Joint Committee on Infrastructure & Police Commission

Meeting of June 25, 2025

City of Nashua Police Department - 9 Riverside Building Assessment

1
E310
ELECTRICAL GARAGE POWER PLAN
1/4" = 1'-0"

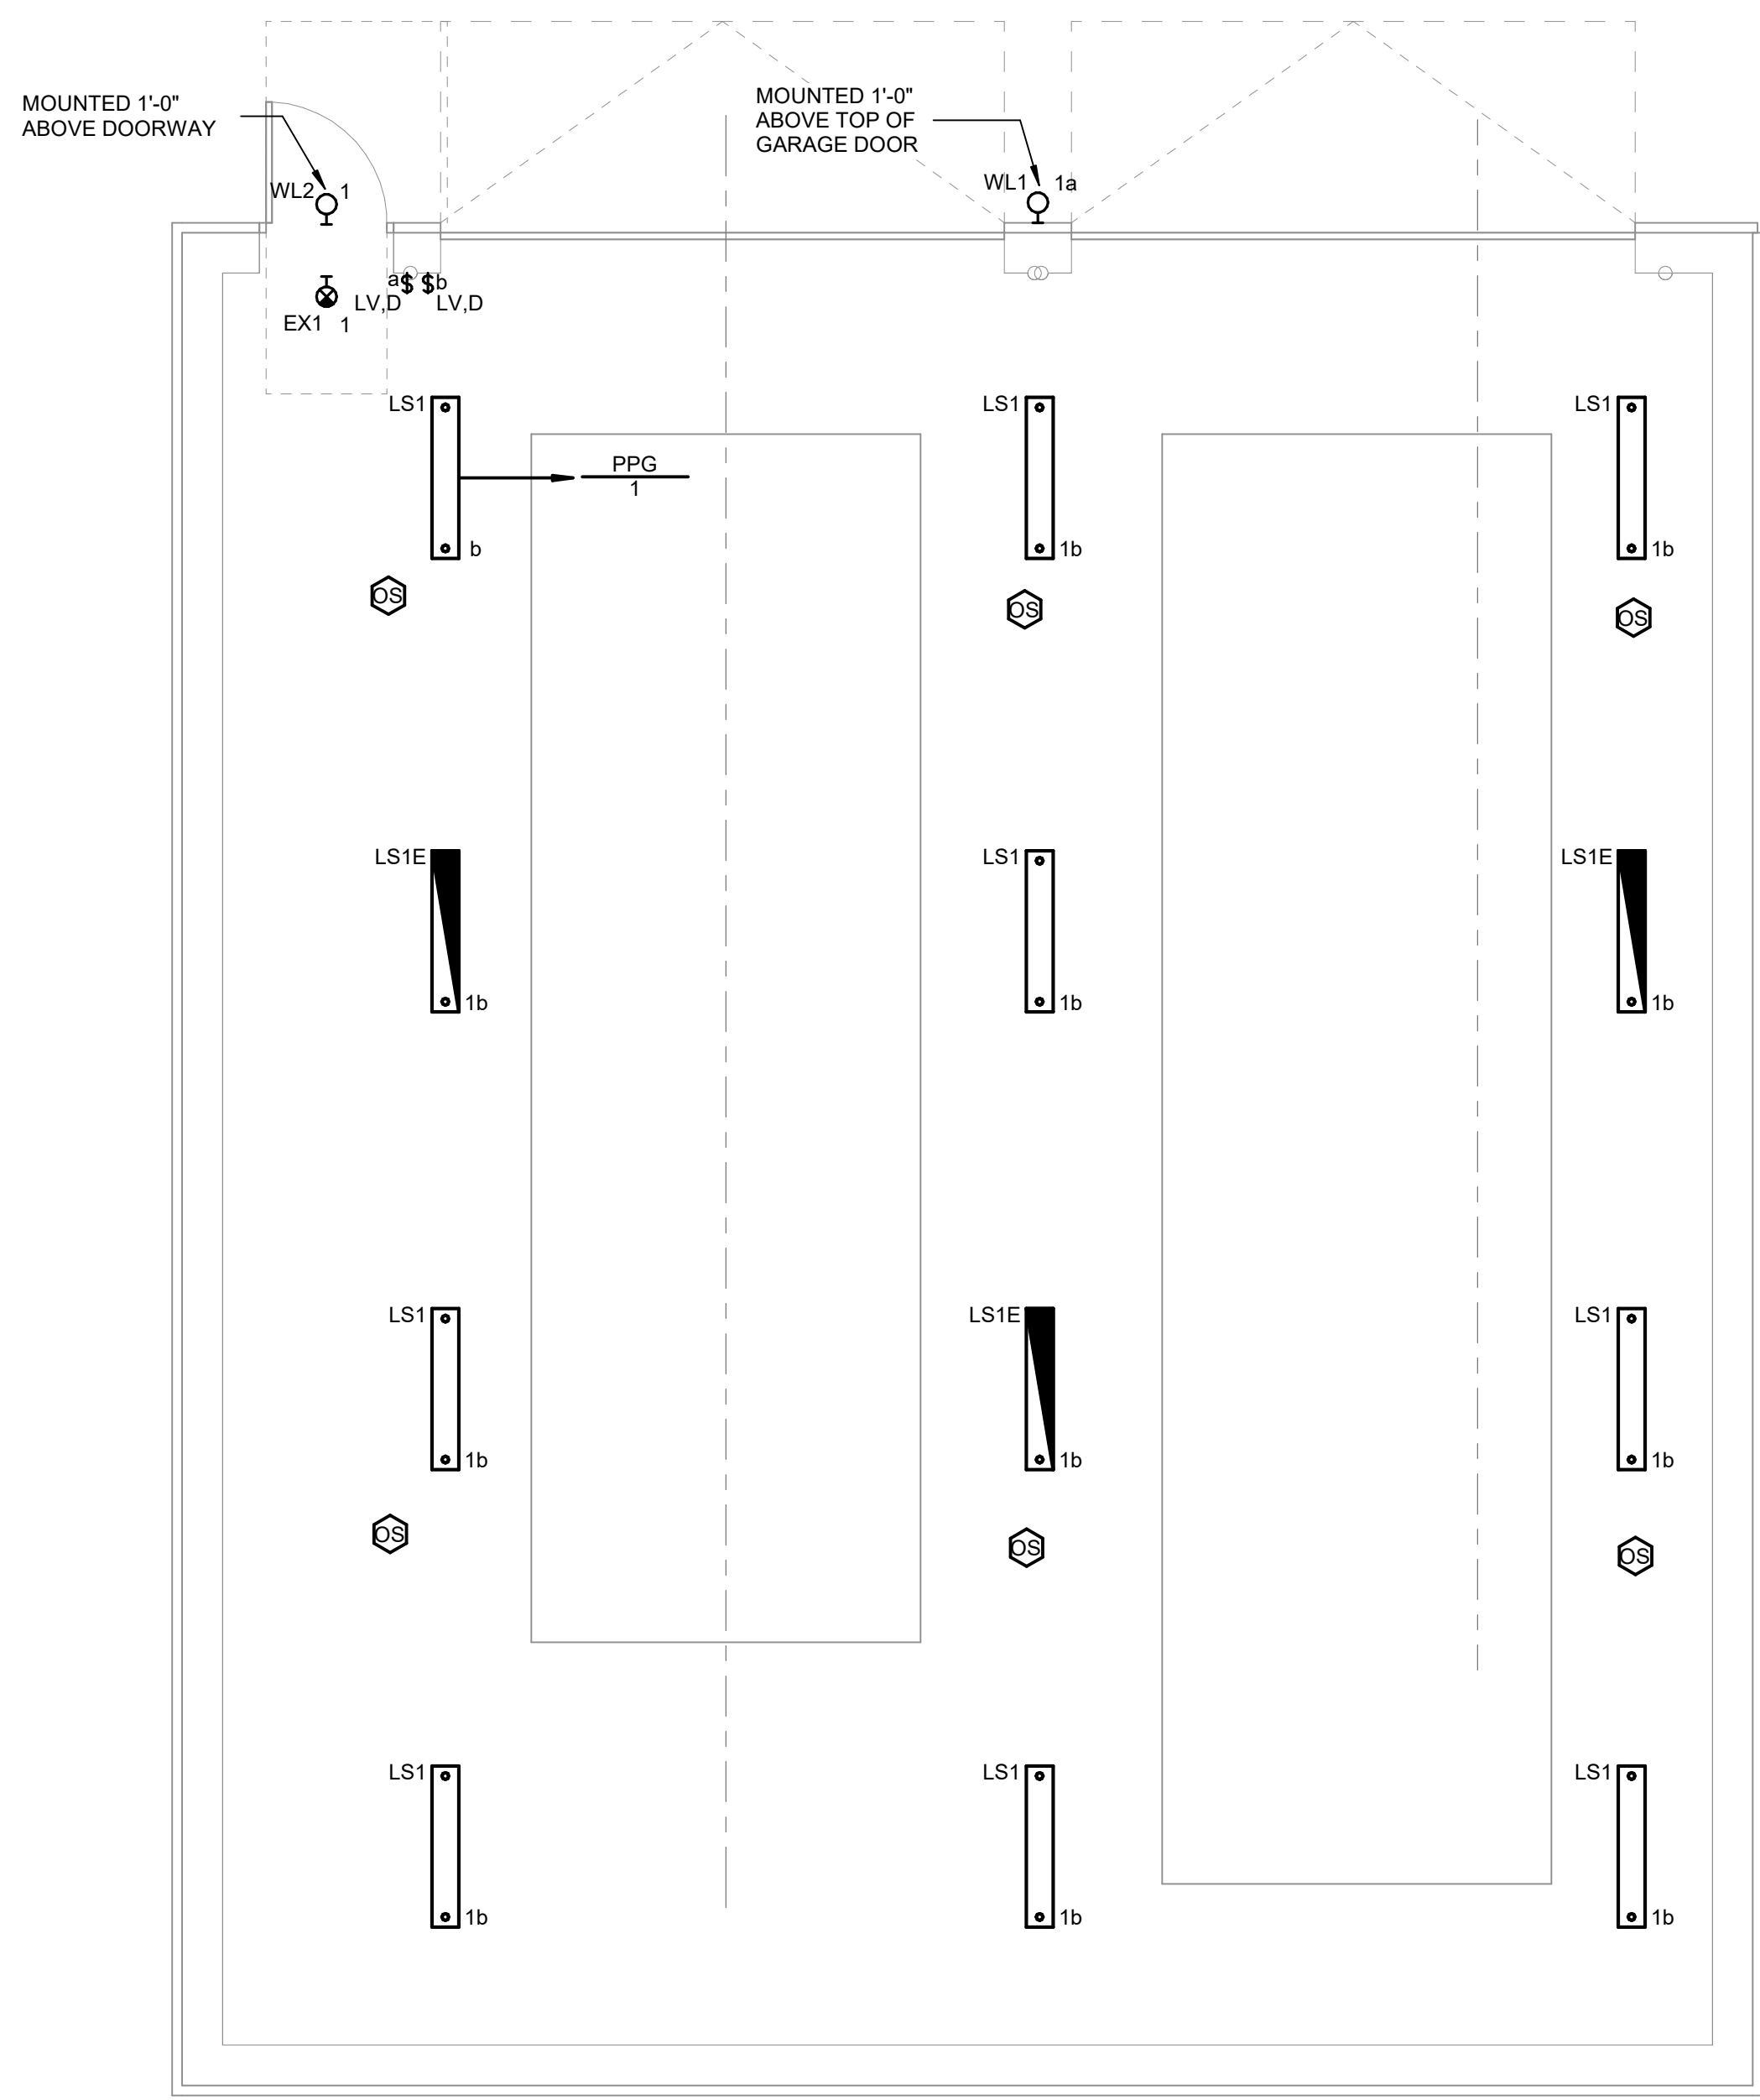
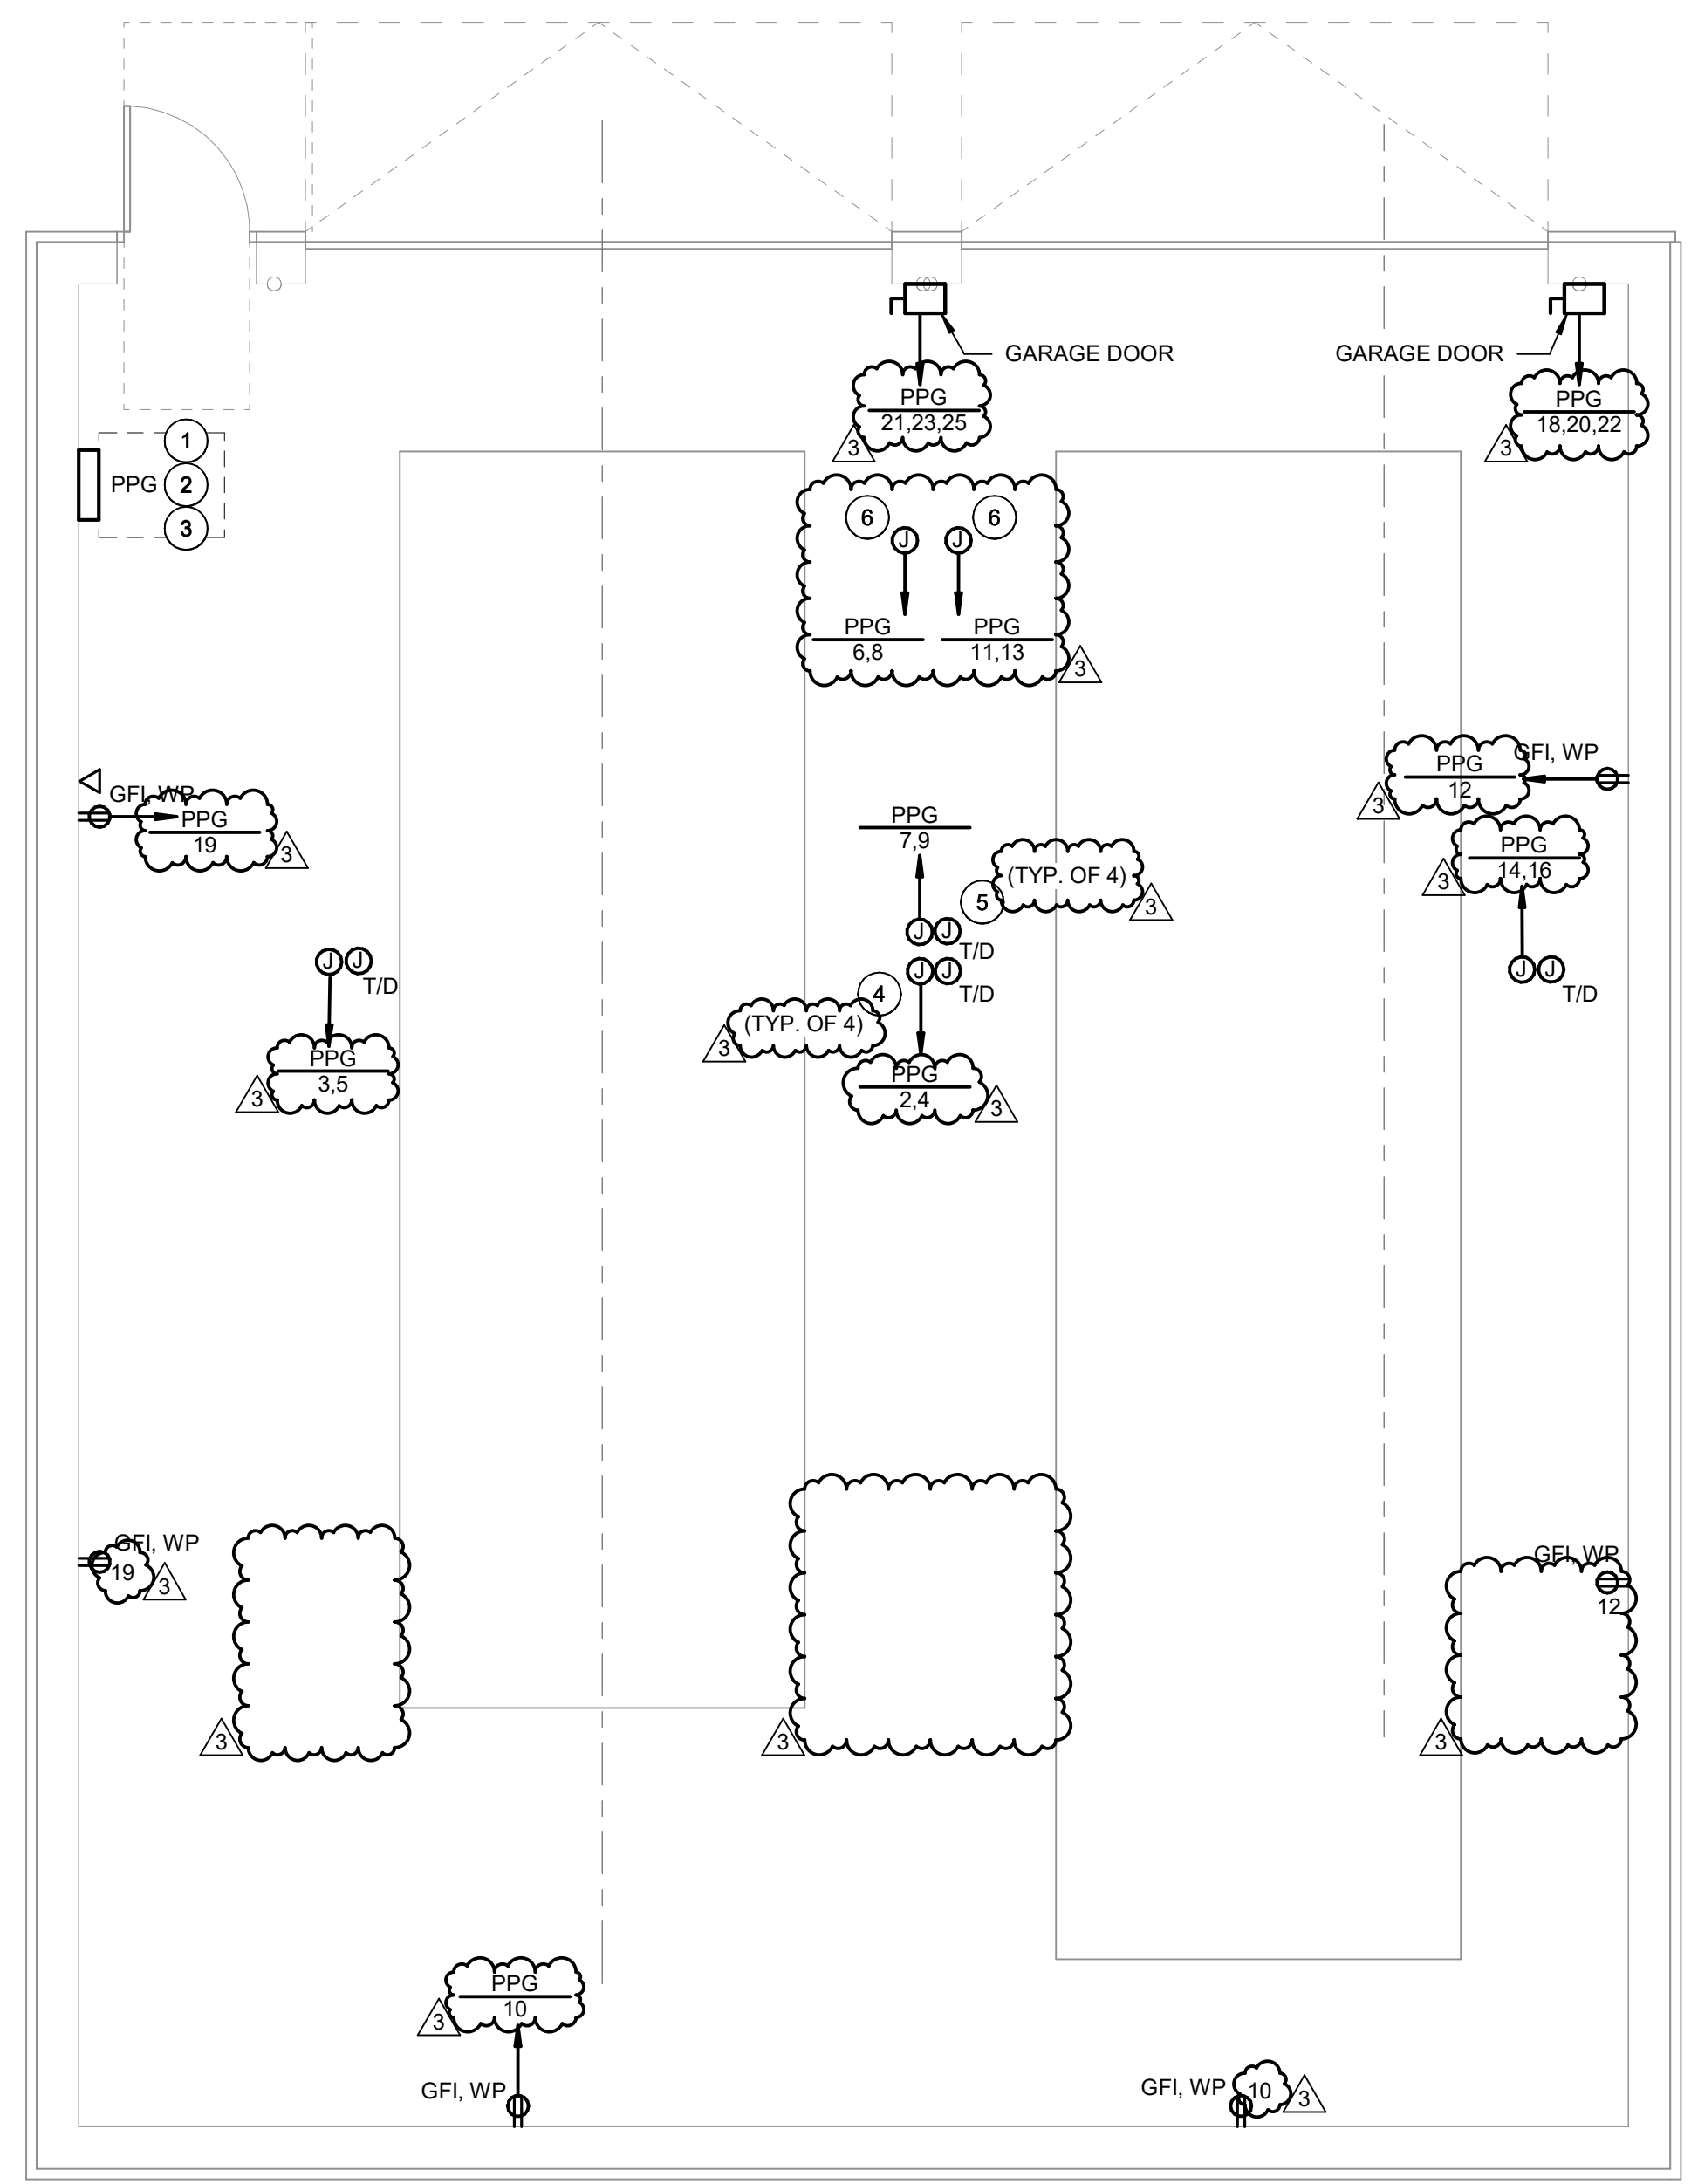
Drawing E310 - Electrical Garage Plan - Electrical plans shows a change of (6) cord resls. A credit for the (2) deleted cord reels will be given. There are now (4) 50A, 208V 1P and (2) 20A, 208V, 1P. Feeds for 50A Cord reels will now change to #6 conductors
